# *Town of Wallingford, Connecticut*

INLAND WETLANDS & WATERCOURSES COMMISSION

### ENVIRONMENTAL PLANNER'S REPORT

**Re:** IWWC#. #A20-6.2 / 155 East Street - Town of Wallingford Sewer Division - Water Pollution Control Facility Phosphorous Reduction Project - modification to IWWC #A18-11.1 - (fill installation in Upland Review Area)

# RARE PLANT - MAIN STREET BRIDGE

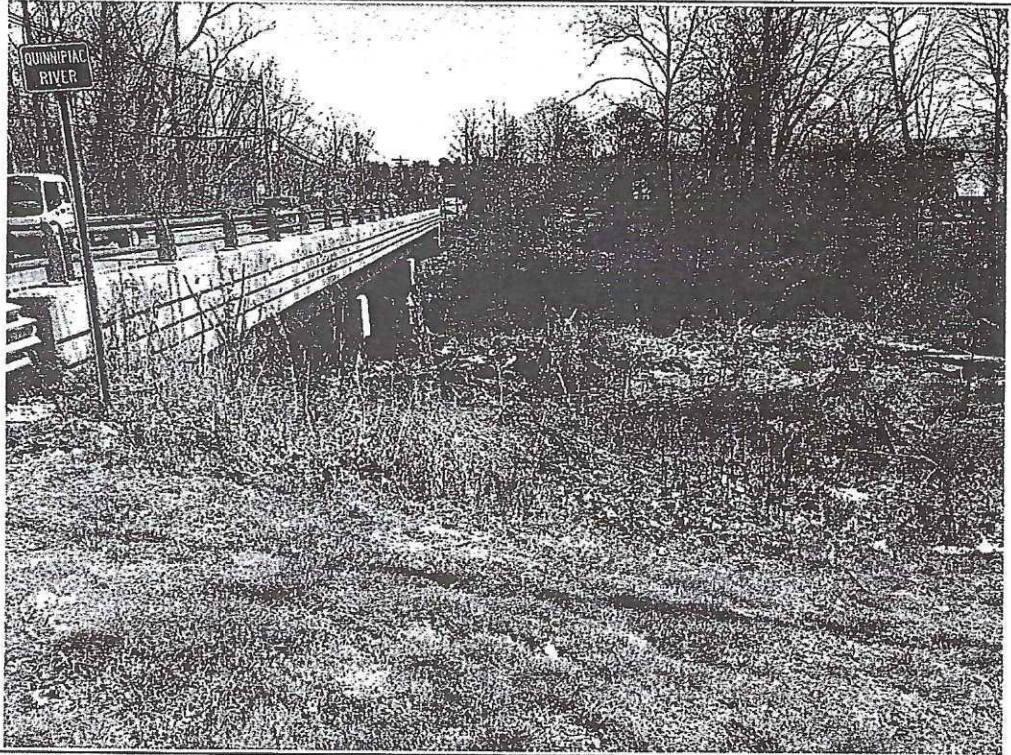
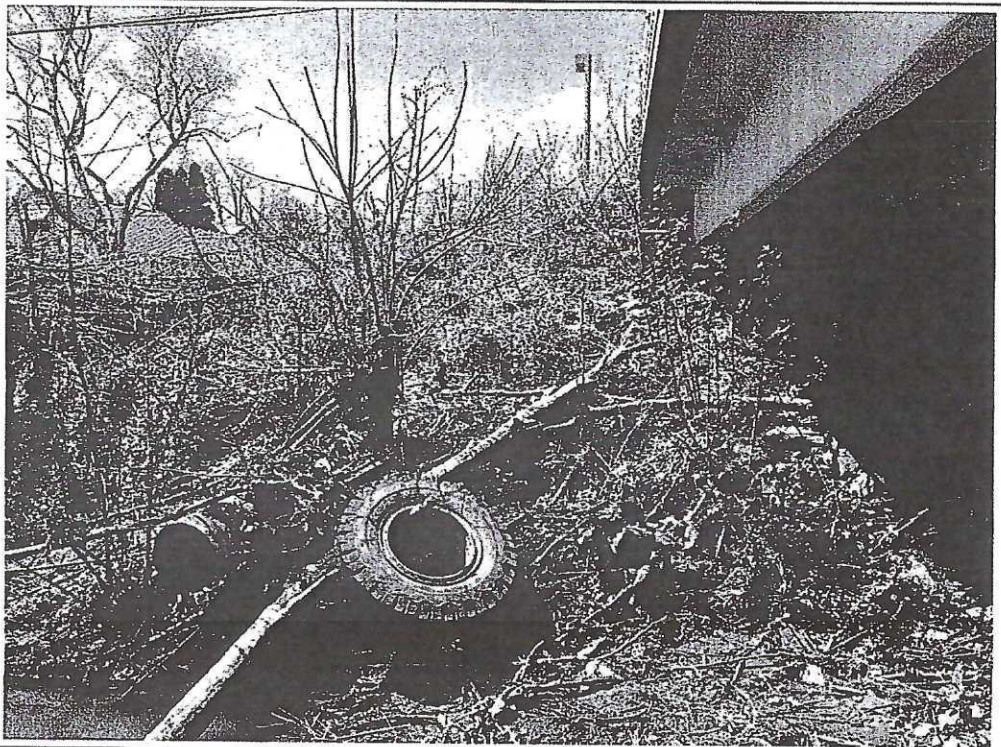
Temporary scaffolding is proposed to be erected across the channel for both sites. Erosion control measures are proposed accordingly to protect wetlands and river's edge, etc.. In addition, DEEP protocols will be implemented for the two species identified under the DEEP Natural Diversity Database requirements – the Eastern Box Turtle and a colony of False Mermaid Weed – as indicated on the plan (and in DEEP correspondence

submitted – see copies in packet forwarded). Please see photos of this rare plant on the Main Street site taken by Project Wetlands Scientist on 4/28/20, attached.

- 1) Applicant was requested to review certain protections as currently proposed for the identified patch of False Mermaid Weed, a protected species, and revise proposed protections if needed.
- 2) Wetlands scientist was requested to submit DEEP correspondence, regarding the two species requiring DEEP protocols to be implemented (per plan) – anticipated to be submitted this week.

- 1) Plans (and Contractor documents) are to be revised to reflect the following:
  - o Call out both worksites are located within State of Connecticut property (Rights Of Way) and said ownership
  - o Depict Upland Review Area boundary on Sheets EX-1 and P-1 in the vicinity of northeast side of Main Street Bridge
  - o Specify Construction Pad materials to be used
  - o Revised protections for False Mermaid Weed: Depict straw wattles to be used for protection on false mermaid weed patch itself (change called for

- by Project Wetlands Scientist). Silt fencing and hay bales are to be installed outside of the False Mermaid Weed patch area.
- Depict on the plans hay bales to be placed on the inside edge of Construction Mats abutting wetlands to protect wetlands from sedimentation tracked by vehicles (as per Detail Sheet P-3).

proposed crossing

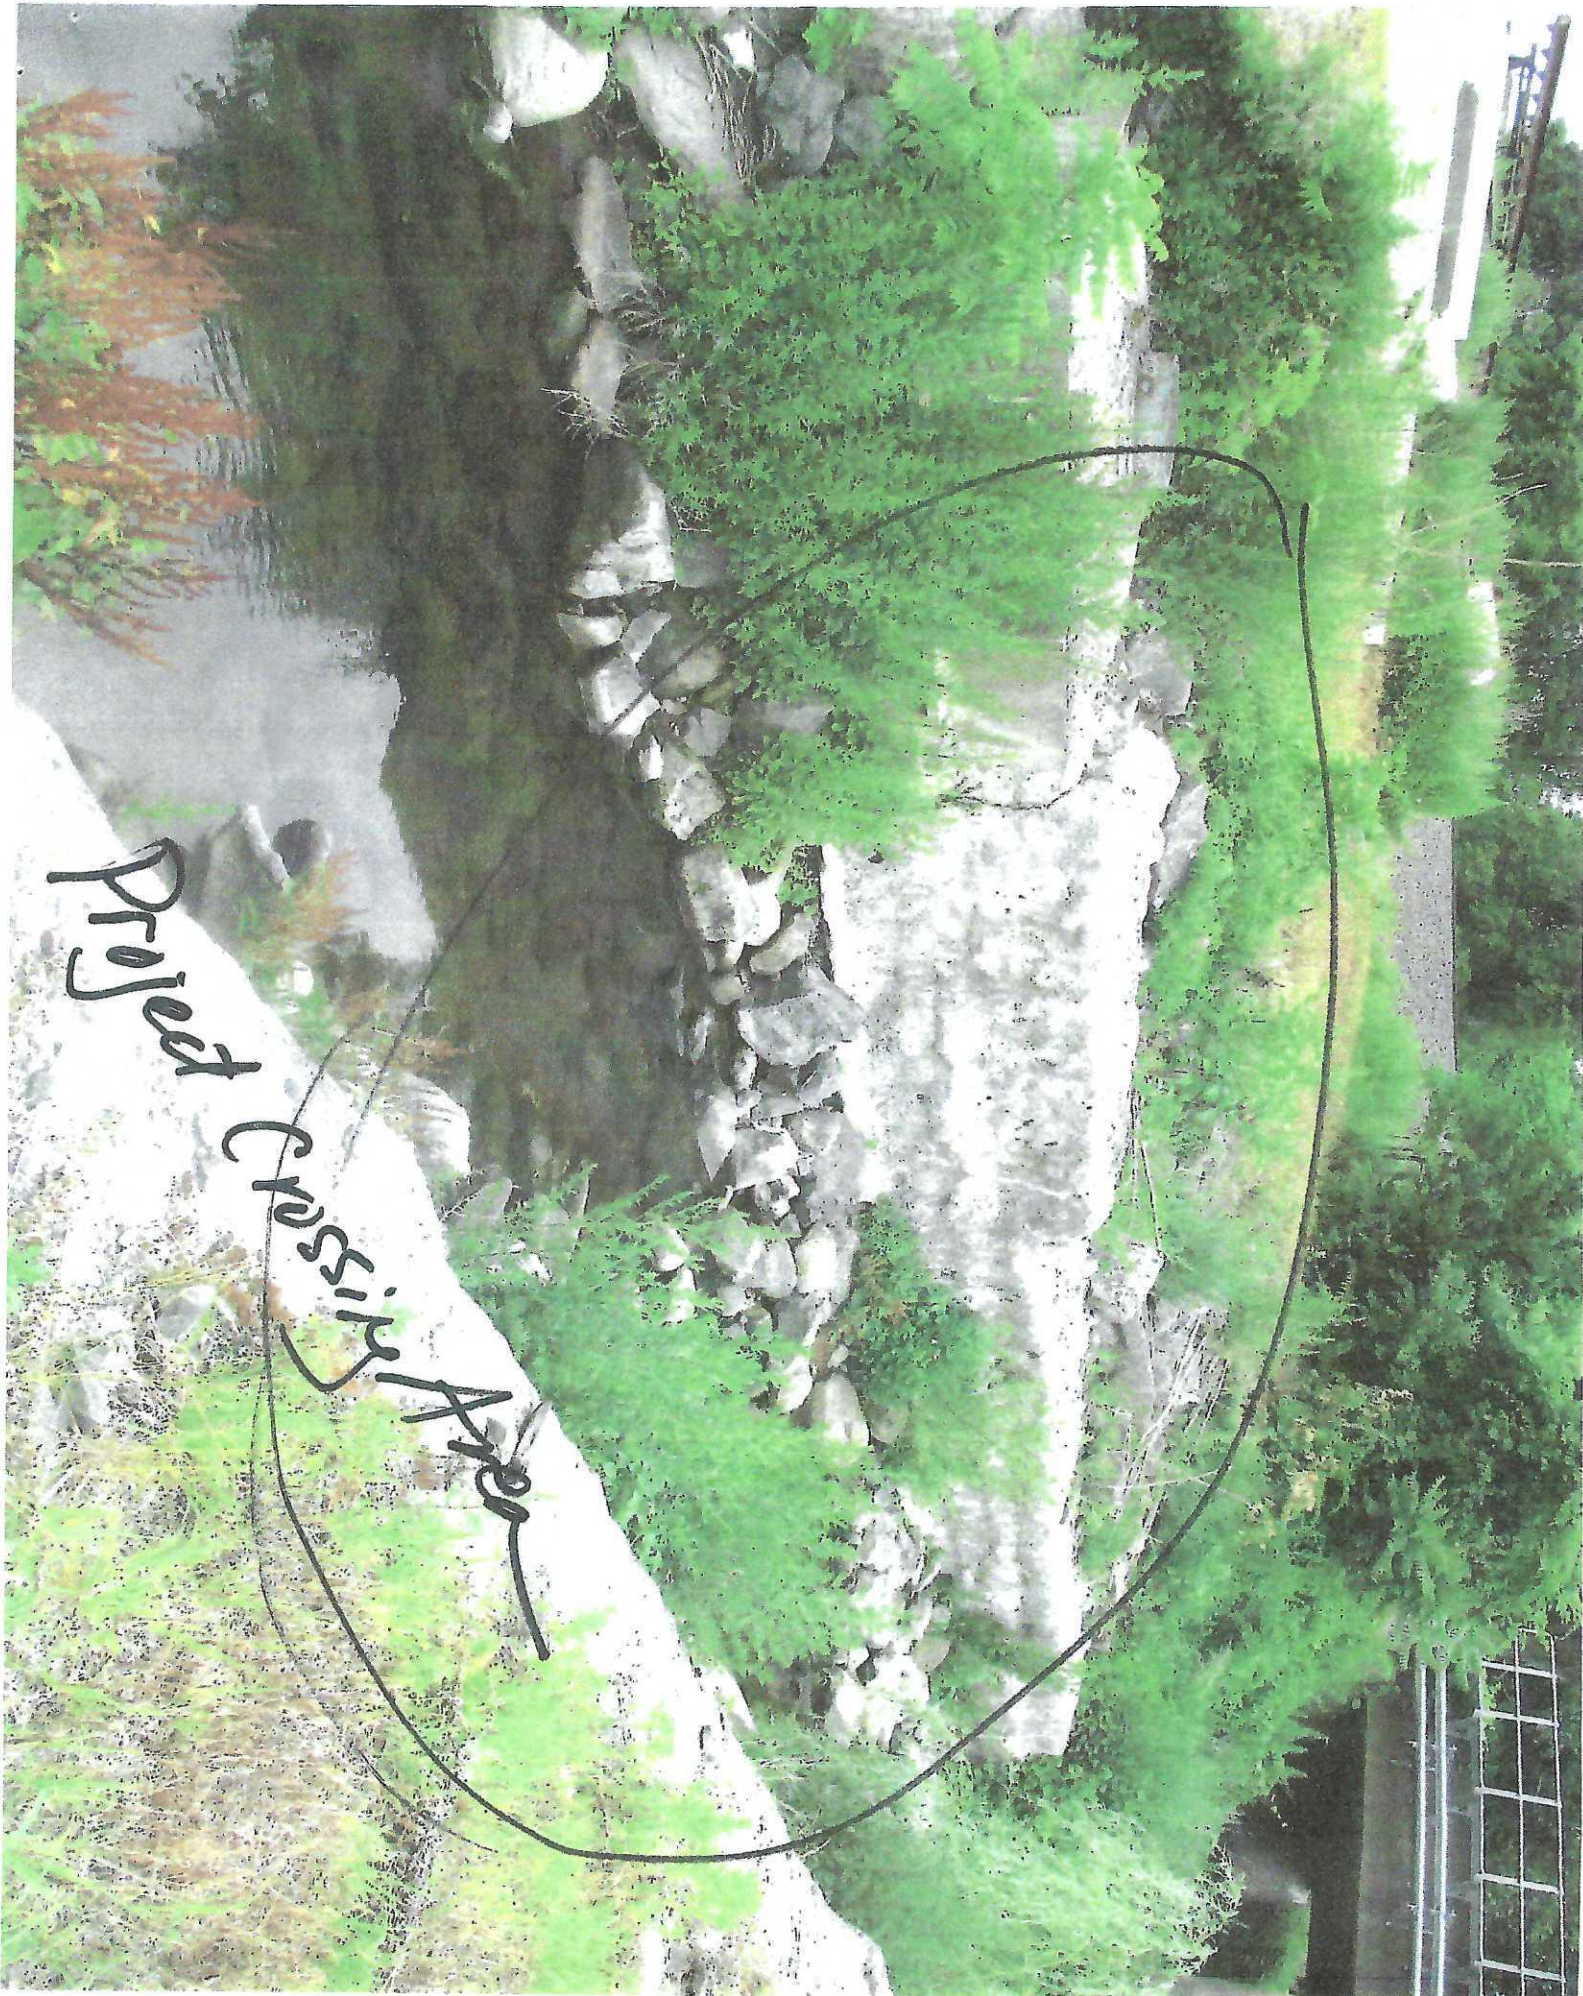
The proposed crossing area is located immediately west of the Railroad crossing where Meetinghouse Brook, flowing west, narrows down in this vicinity where the river was channelized in years past with gabions, boulders, riprapping, etc.. There are several Sewer Division facilities and easements and riprap protection areas in the vicinity. There are no wetlands delineated through the proposed activity stretch of river - the two "wetland flags" depicted on plan being simply the call-out used by the Wetlands Scientist to denote the watercourse edge (see copy of Wetland Report attached to Application from submitted).. A narrow band of riparian wetlands occurs further down the river on either side. On the south side, on the 120 Church Street property (which supports the heliport site and a building of several industrial concerns) at the rear of the parcel, the land is mowed almost to the edge of the very steep bank. On north side, on the 494 Main Street property, the rocky, weedy river bank rises sharply to meet a graveled, busy, congested concrete yard for United Concrete products.

at the closest in this vicinity. A minor amount of activity is proposed to take place in the Upland Review Area on the south side (210 s.f.) which is proposed to be altered for filling associated with the southwesterly modular block retaining wall installation and associated silt fence protection installation. On the north side of the bridge, approximately 1,830 s.f. of impact will occur associated with the installation of the bridge footings, abutment, filling for roadway area (approx.. 30 foot-long), and two modular block retaining walls, and associated silt fence protection installation. No disturbance is planned for the area between the silt fencing and the riverbank itself.

The proposed dewatering area and materials laydown area -- currently proposed on the south side - will be revised next week to be re-located further back entirely out of the FEMA floodway and floodplain (see both boundaries depicted on the plans) and thus avoiding that issue. In the crossing area, the Floodway is contained within the walls of the riverbanks through this narrow river corridor section.

- 1) Erosion control measures are in place and meet the approval of the Environmental Planner for adequacy prior to any further work being conducted onsite.
- 2) Water & Sewer Division concerns are complied with as per Erik Krueger's memorandum dated June 30, 2020, attached to this Notice of Decision.
